JONES & BEACH ENGINEERS INC.

RE: Response Letter
0 Ledgewood Drive, Portsmouth, NH
Tax Map 222, Lot 6A
JBE Project No. 25071.1

We are in receipt of comments from the Technical Advisory Committee dated August 31, 2026. Review comments are listed below with our responses in bold.

Plan Name:	SITE PLAN MAP 229, LOT 6A
Project:	LEDGEWOOD DRIVE LLC LEDGEWOOD DRIVE, PORTSMOUTH, NH 03801
Owner of Record:	ST NICHOLAS GREEK ORTHODOX CHURCH 40 ANDREW JARVIS DRIVE, PORTSMOUTH, NH 03801

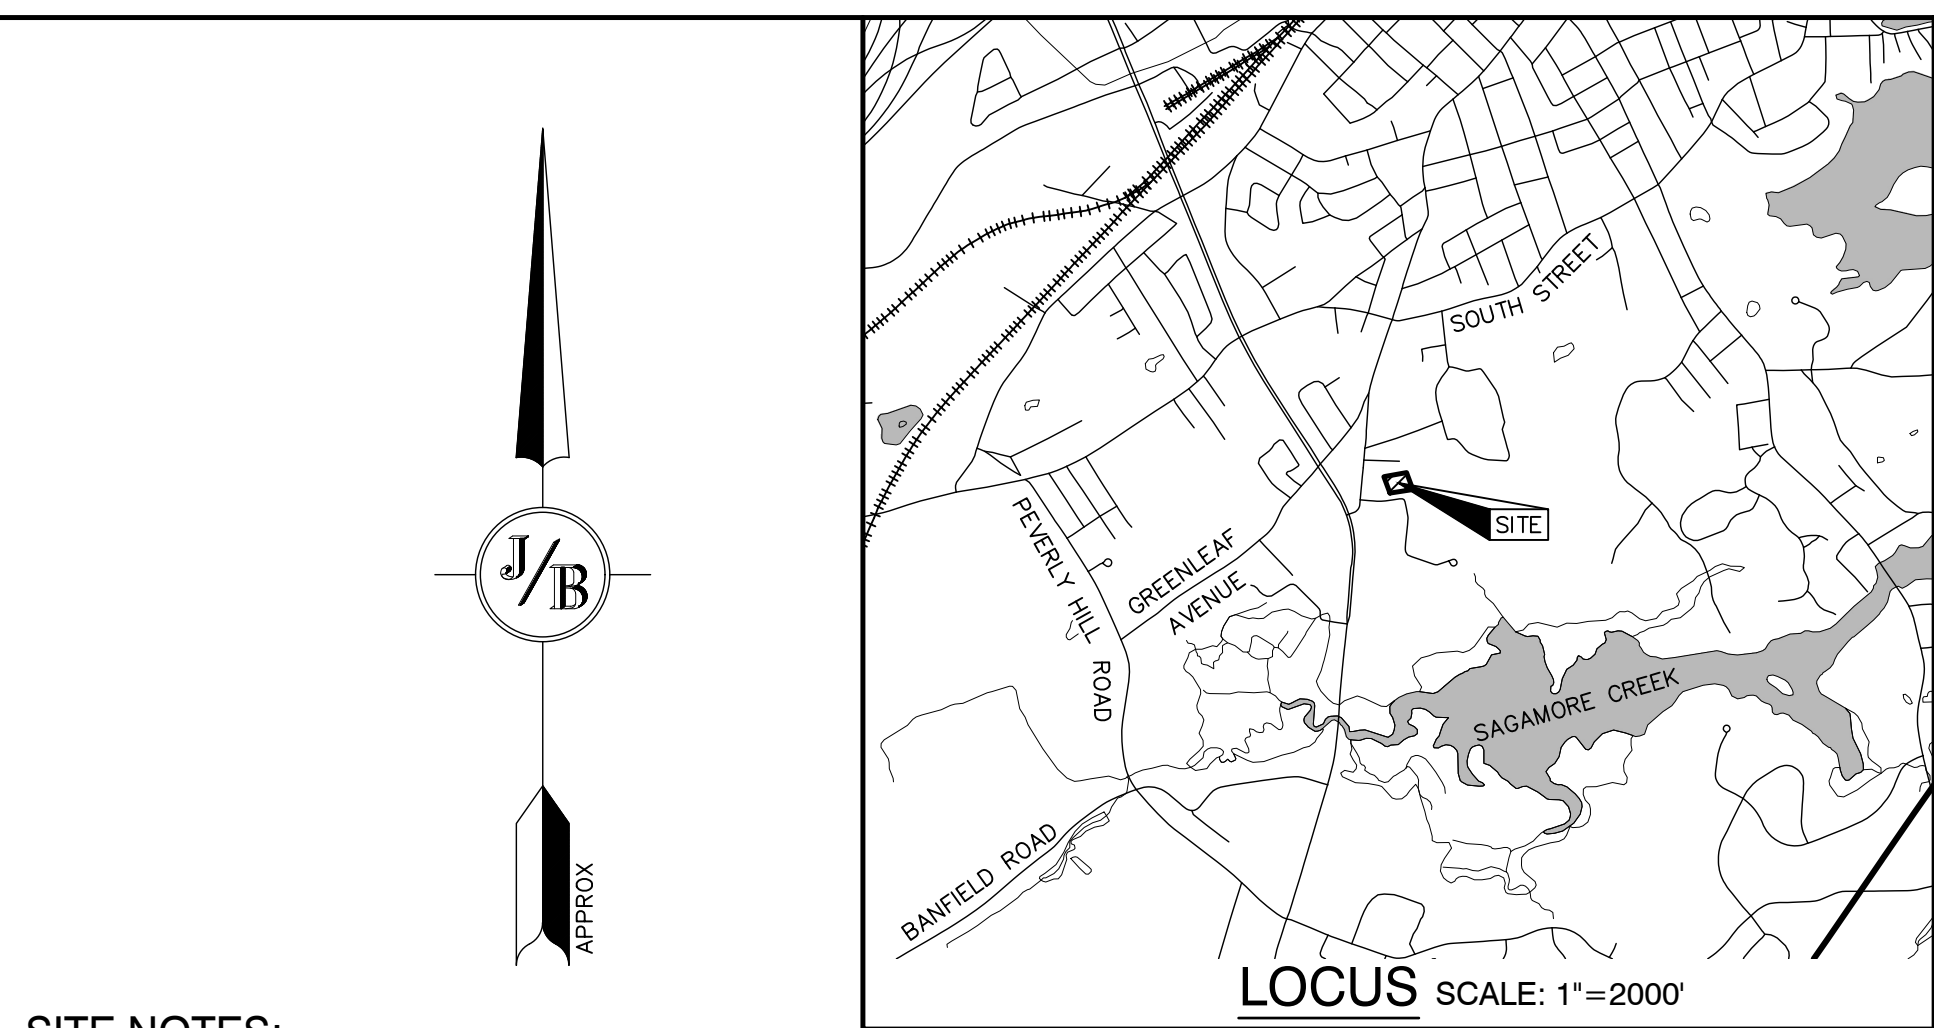
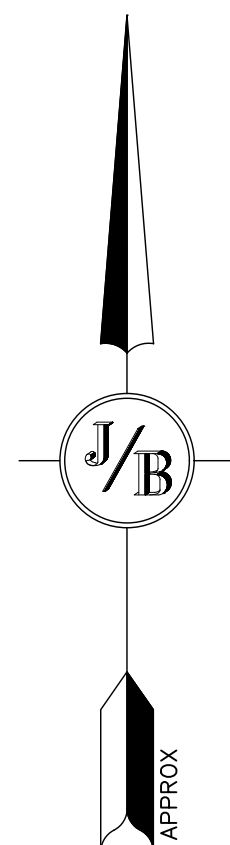
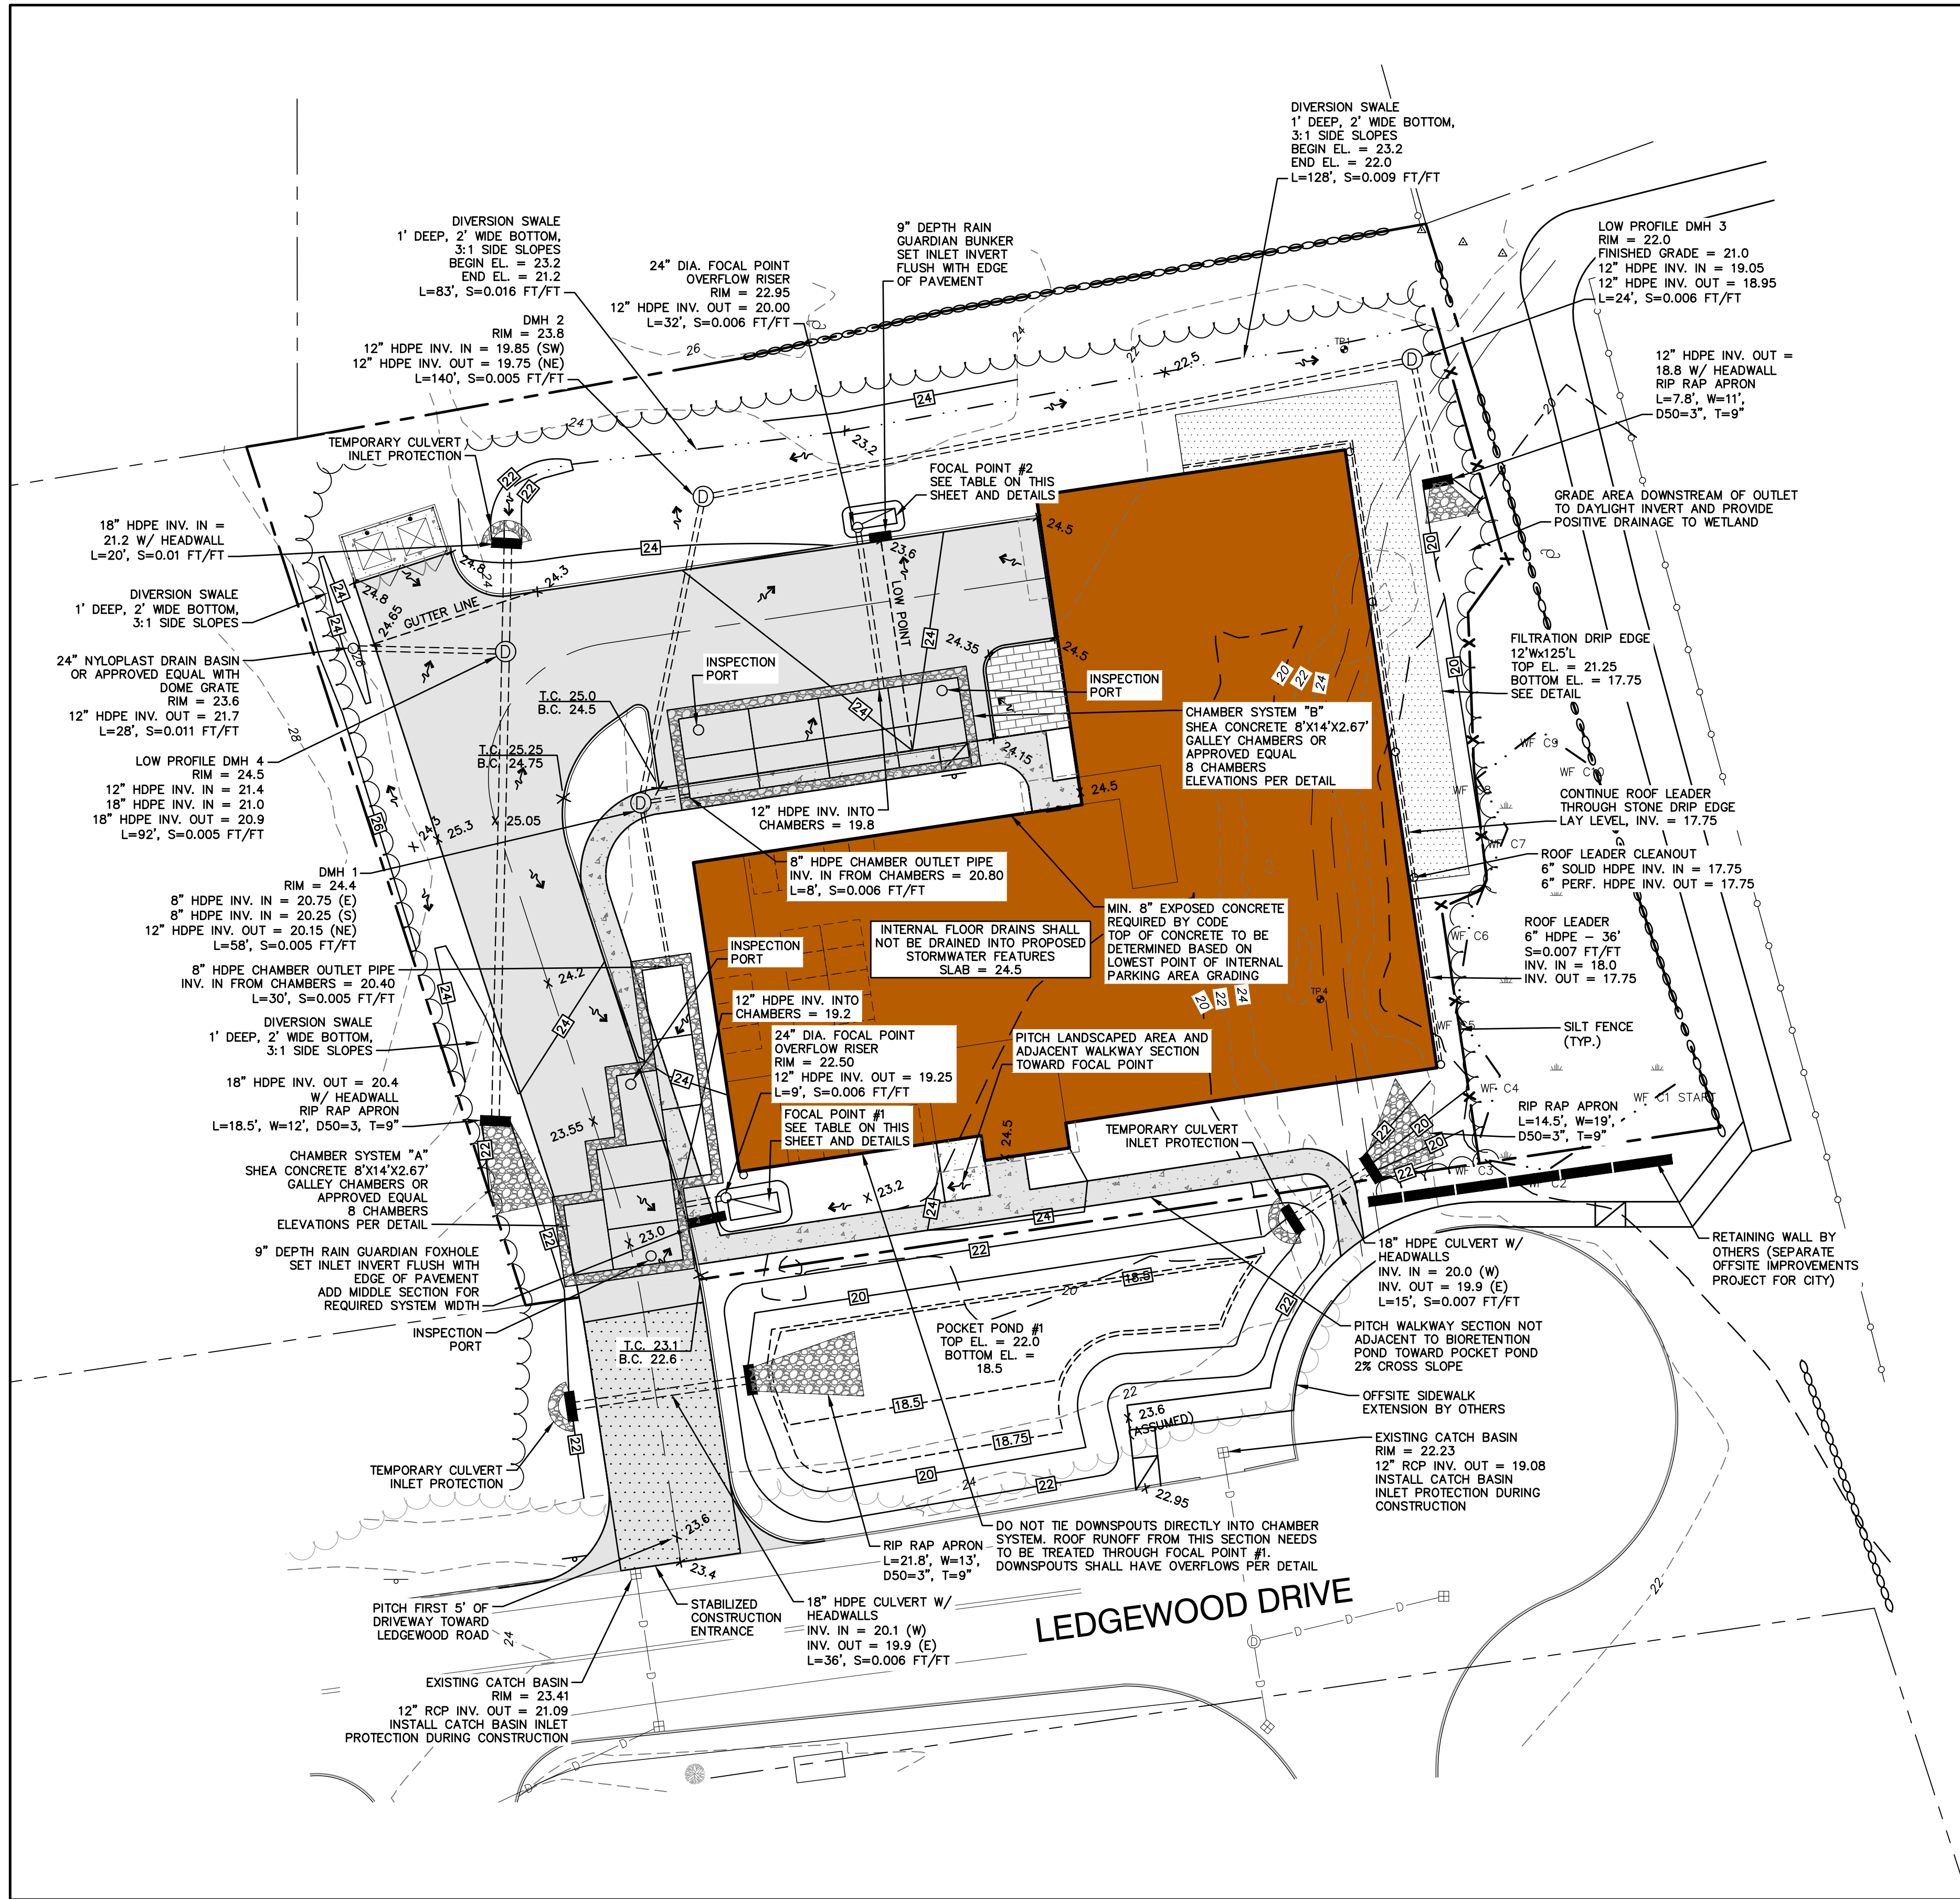
1. *Dumpster needs to comply with Section 10.575*

Response: As noted on Sheet C2, the dumpster has been relocated to conform with the setbacks per Section 10.575 of the Zoning Ordinance.

C4

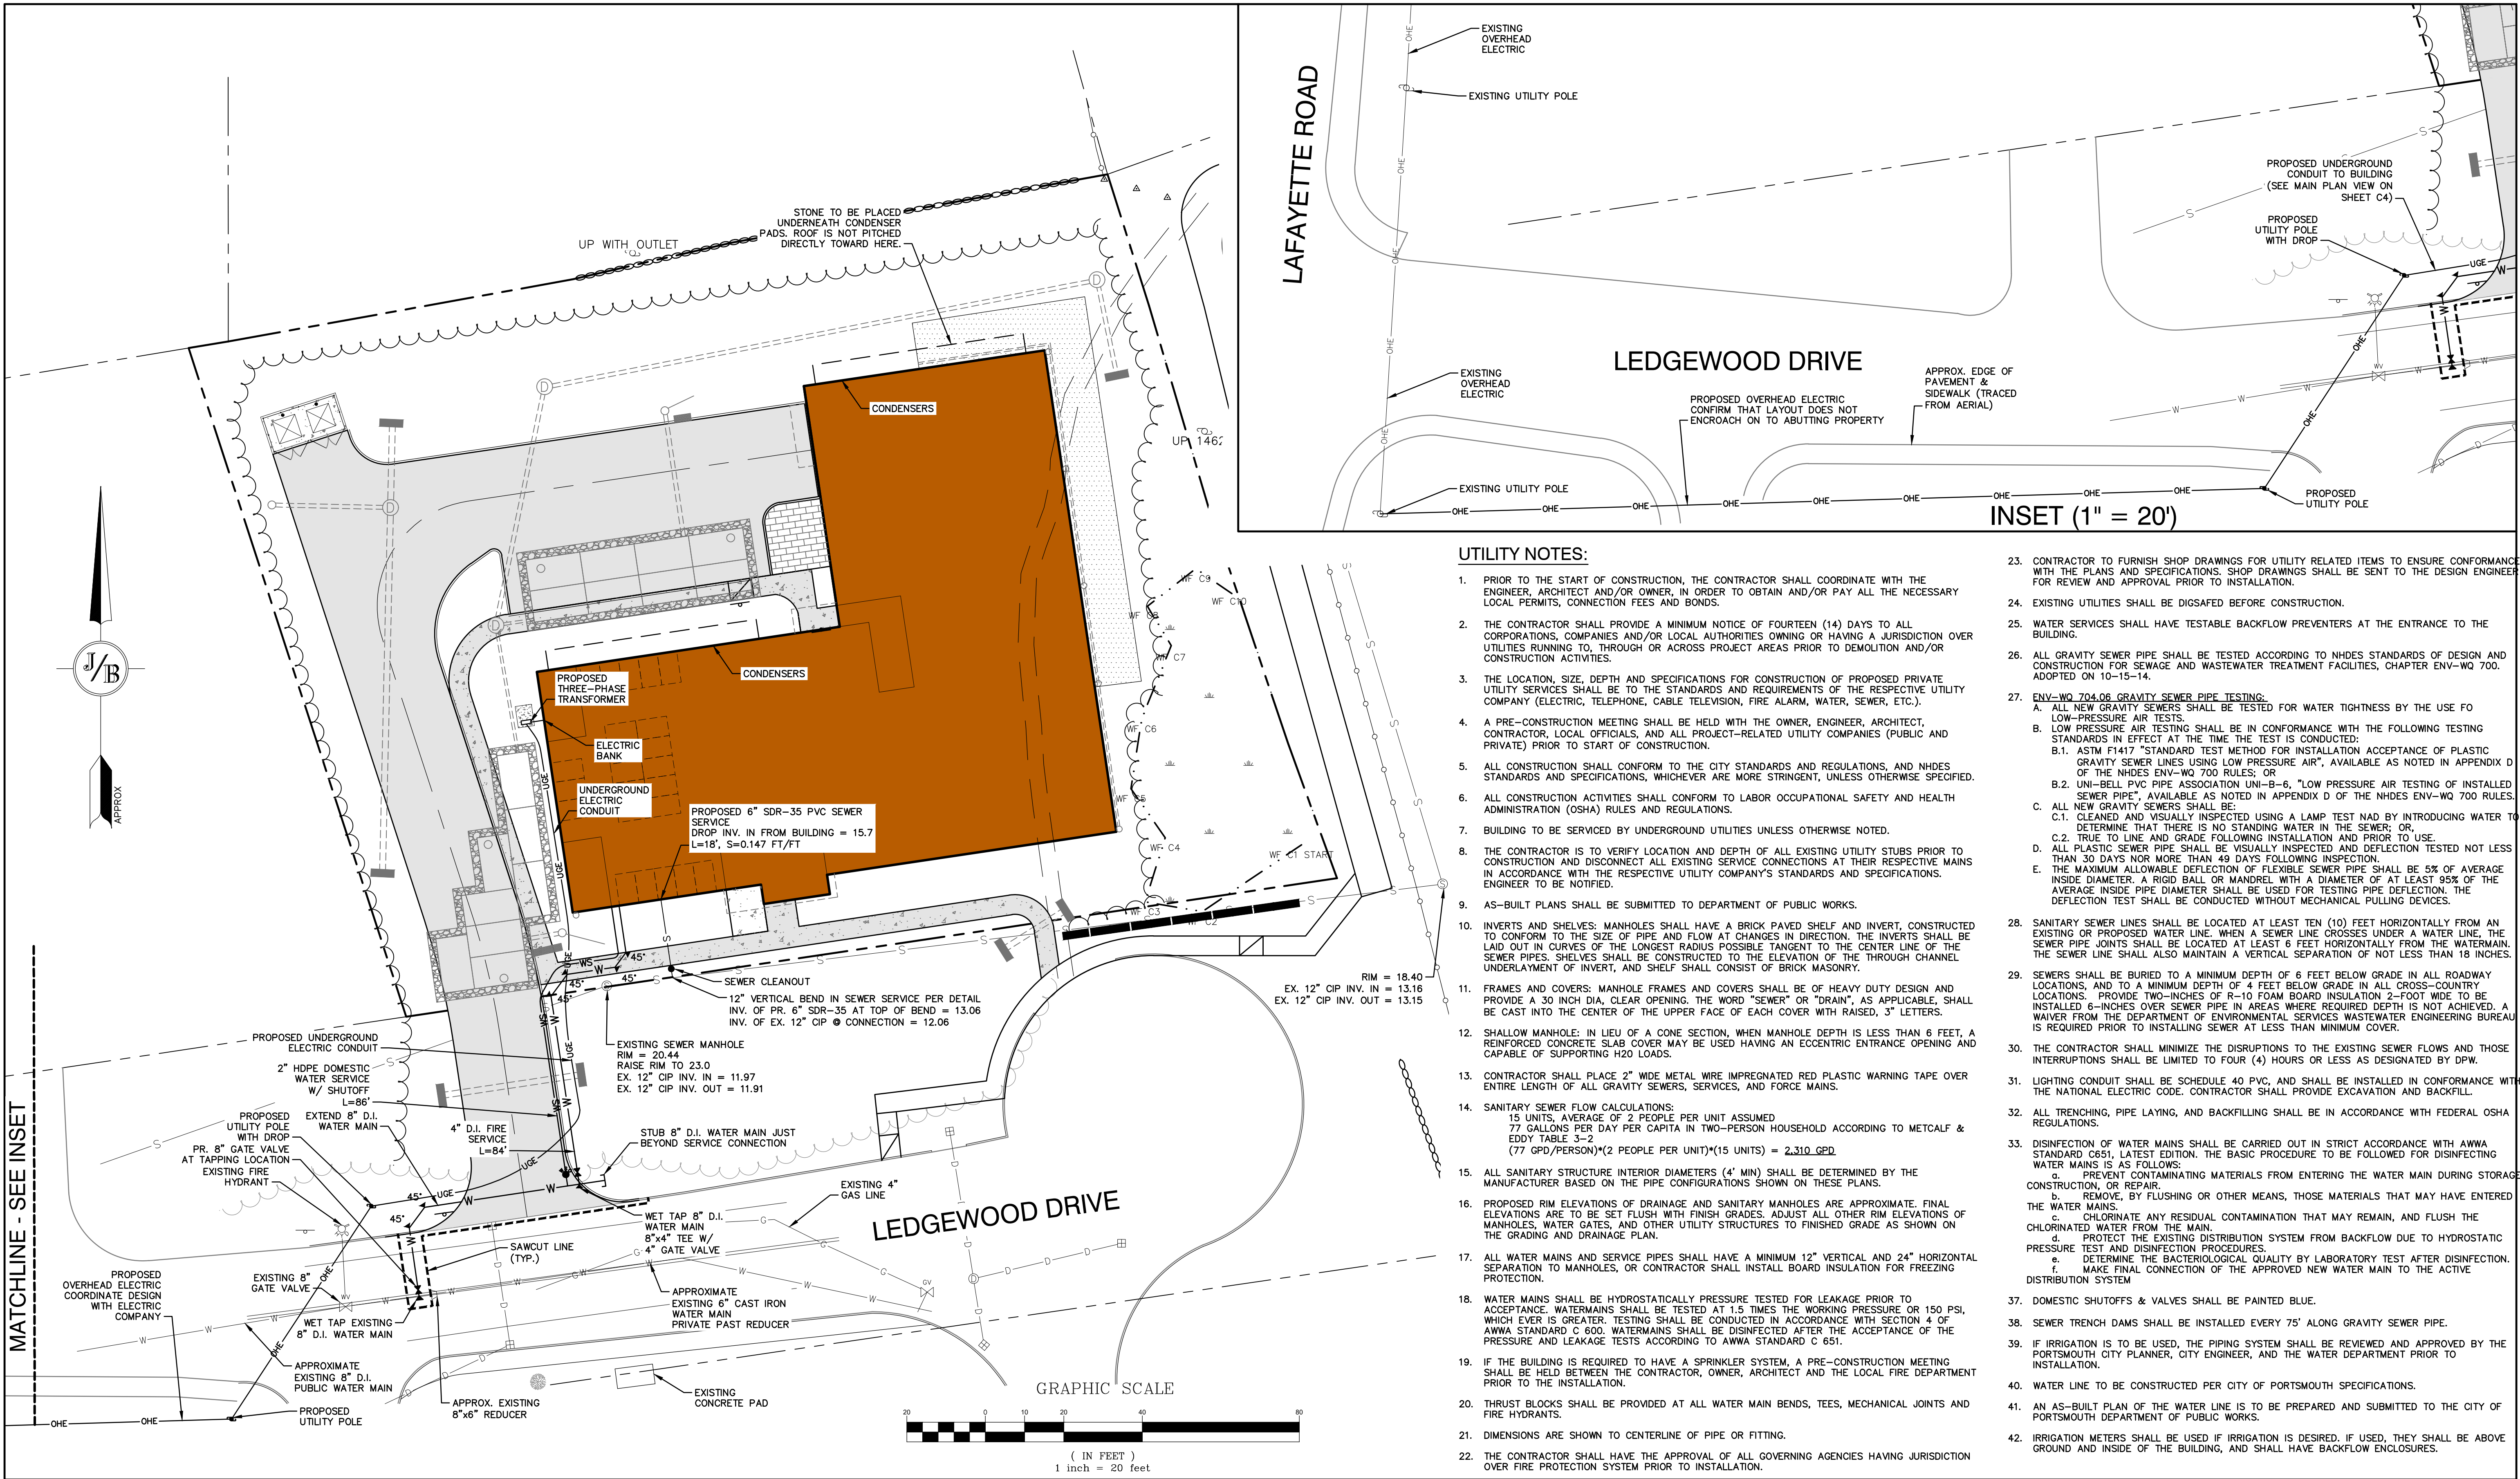
10. *Fire and domestic water services must have their own connections to the water main.*

Response: Fire and domestic services are now shown with separate connections to the extended water main on Sheet C4.
